Response to Reviewer 2

Manuscript title: Reconstructing the Salgar 2015 Flash Flood Using Radar Retrievals and a Conceptual Modeling Framework: A Basis for a Better Flood Generating Mechanisms Discrimination

Authors: Nicolás Velásquez, Carlos D. Hoyos, Jaime I. Vélez, and Esneider Zapata

Figure 1: Speeds recorded at the Santa Rita Basin located in the Aburra Valley. This watershed has an area of $48km^2$ and a mean slope of 45%.

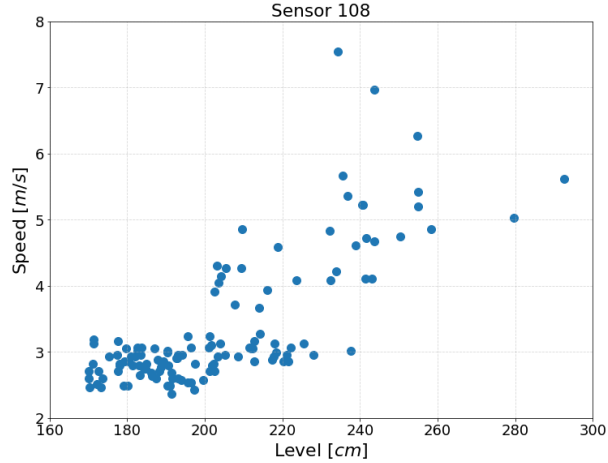
P10L254 : the selected velocities are relatively high, especially for average cross-sectional velocities (see Lumbroso et al., 2012). The provided estimates may be a little high. Are there some films that could help reduce the estimation uncertainties and provide some ideas of possible peak velocities. According to figure 15, the flood extent has been mapped, and probably flood marks identified, along a large part of the main stream. Since the second event has been produced mainly in the upstream part of the watershed, it would have been interesting to base the analysis on some other peak discharge estimates along the main stream and its tributaries. The ability of the proposed model to reproduce the spatial distribution of the flood peaks on the watershed could have then been tested.

About speeds: In local gauged basins with similar characteristics we have recorded peak flow speeds oscillating between 5 and 7 m/s during cases still not considered as flash floods (Figure 1). We have included this comment in the manuscript. By assuming an area of 37 m^2 and the described peak speeds, we estimate that the observed flash flood peak flow may vary between 185 and 222 m^3s^{-1} .

Figure 2: Hourly rain gauge-radar QPE comparison using two rain gauges installed 3 days after the flash flood event.

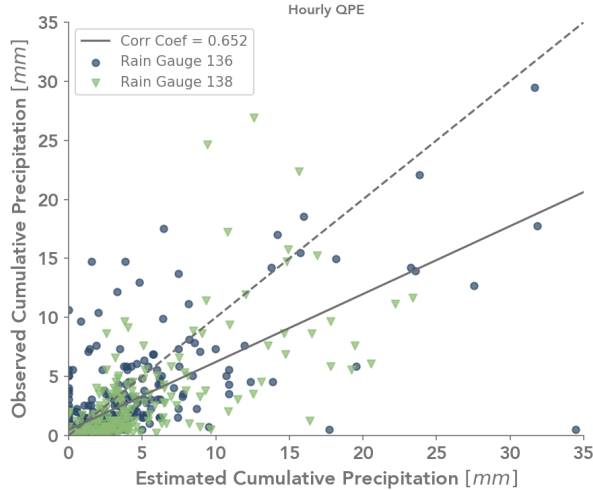
P18 The radar rainfall rates must be quality checked. The area is relatively far from the radar and mountainous, two settings that could introduce uncertainties and errors. Are there some available raingauge measurements on the affected watershed or on nearby areas ? How do the radar-based rainfall estimates compare with corresponding raingauge measurements ? The two considered rainfall events are spatially heterogeneous unlike what is stated further in the manuscript. The upper part of the watershed is almost not affected by the first event. It would be essential to distinguish this upper part in the rest of the analysis since the average simulated soil moisture and runoff components may hide a significant spatial variability. Conclusions drawn on the importance of the first event for the saturation of the soils could be largely nuanced by a more detailed spatial analysis

About rainfall estimates The radar QPE methodology was developed by Sepulveda and Hoyos (2019) using rainfall gauges and disdrometers within the radar domain. Their results indicate that the rainfall estimation works well within a radius of 120km (La Liboriana is located at 90km). Despite the distance between the radar and the basin, and the mountains between them, there are no blind spots in this region for the radar. Figure 2 shows a comparison between the radar QPE and two rain gauges stations installed 3 days after the event. The correlation among the hourly precipitation records is 0.65.

Figure 3: Temporal evolution of discharge during Event 2 in different locations along the watershed’s main channel. The upper location corresponds to 15% of the area of the basin, and the other downstream locations to 52%, 76%, and 100% of the watershed, respectively.

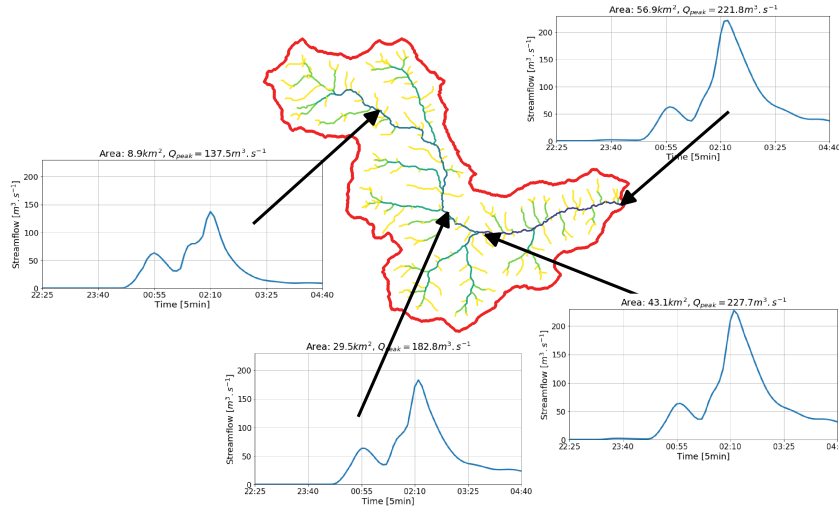
P19L494 It is essential for the second event, according to the spatial rainfall heterogeneities, to provide some distributed simulation results : what part of the flood volume has been produced on the 15% upstream part of the watershed ? Is the contribution from the intermediate watershed significant ?

Considering the reviewer comments, we decided to add an additional Figure for Event 2. Figure 3 shows the temporal evolution of discharge during Event 2 in different locations along the watershed's main channel. The upper location corresponds to 15% of the area of the basin, and the other downstream locations to 52%, 76%, and 100% of the watershed, respectively. In terms of volume, 73 Mm^3 of the total 144 Mm^3 simulated at the outlet of the basin are generated on the 15% upstream part of the watershed, corresponding to about half of the total mass. In terms of peak flow, due to the slope and velocity changes, the simulated discharge at the 15% upstream part of the watershed corresponds to 61% of the peak discharge at the outlet of the basin.

Figure 4: Sensitivity analysis of a) infiltration, b) runoff speed and c) subsurface speed parameters.

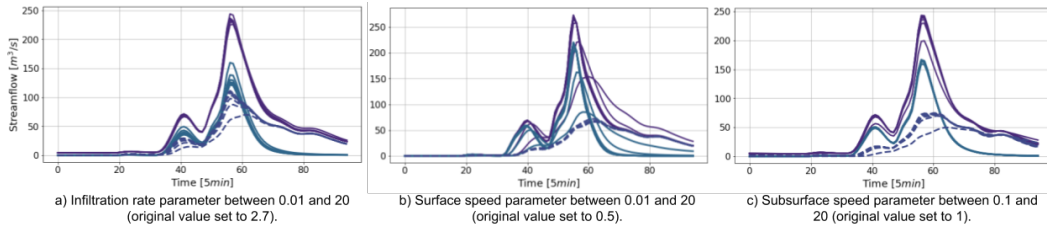
Part 4 the simulation part, and the interpretation of the results is not uninteresting. But the spatial variability must be shown and commented as suggested before and a clear difference must be made between these simulation results and the real-world. What is presented is the outcome of a numerical model, with the selected parameter and initial state values: some other choices could have provided equally good results if compared to the only available estimated peak discharge but very different flow separation between the various simulated components. Again, the choice of the various parameter values must be clearly justified. Some sensitivity analyses of the results and partitions to these values would also be welcome to strengthened the analyses: are the conclusions always the same if the values are varied over a reasonable range ? I have doubts.

We have restructured some parts of the manuscript, and we have added results from a sensitivity assessment and additional spatio-temporal analysis of Event 2. Taking into account comments made by both reviewers, we added a summary table with the model parameters and an explanation of their origin. Figure 4 shows the results of a sensitivity analysis of the hydrological simulation during the second rainfall event, varying the infiltration rate, and the surface and subsurface speed parameters. The aim of the sensitivity analysis is to evaluate the robustness of the overall results, considering the fact that the quality of some of the watershed information is limited. The overall simulation sensitivity results show the main results described in the previous paragraphs are, in fact, robust to almost all changes in the mentioned parameters, with surface runoff associated with convective rainfall controlling the magnitude of the peak discharge during the Event 2. Changes in the infiltration rate (left panel in Figure 4) result in peak flow changes with a magnitude less than 7%, and changes in the subsurface velocity parameter (right panel in Figure 4) lead to peak flow changes with a magnitude less than 20% the original simulation. The model highest sensitivity, and hence the largest uncertainty source, appears to be related to the surface speed parameter (middle panel in Figure 4), particularly in the low-end values. Although some of the surface speed values used in the analysis are unrealistically low, it is noteworthy to report that these values lead to the attenuation of the hydrograph and the reduction of the peak flow.

Figure 5: Event 2 simulated varying the percentage of capillary storage in the initial conditions.

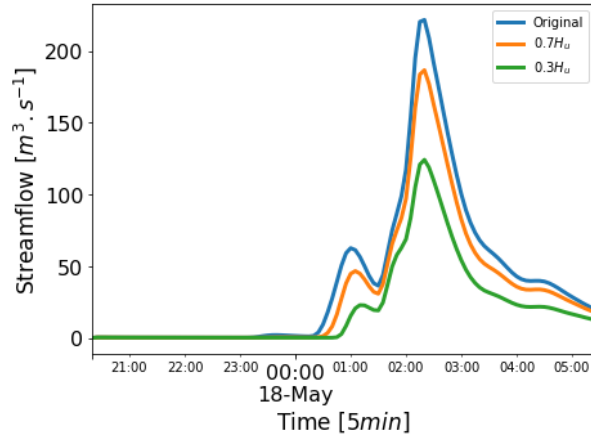
P22L562 Why should the soils be wet upstream since this area has not strongly been affected by the first rainfall event?

As mentioned before, and as shown in Figure 5 in the revised manuscript, there is rain in almost all the basin during Event 1, about 21 mm in the upper part of the basin. Also, from Figure 10 in the revised version, we can see variations in the capillary and gravitational storages associated with Event 1 in the higher numbered groups. The capillary storage remains high in almost all the basin until the start of the second event. According to the conceptualization of the model, the gravitational storage and surface runoff start to interact when the capillary storage is full. In this case, this situation is set up by Event 1. We also made some evaluations for Event 2 using dry initial states, with no flooding in the results (Figure 5).
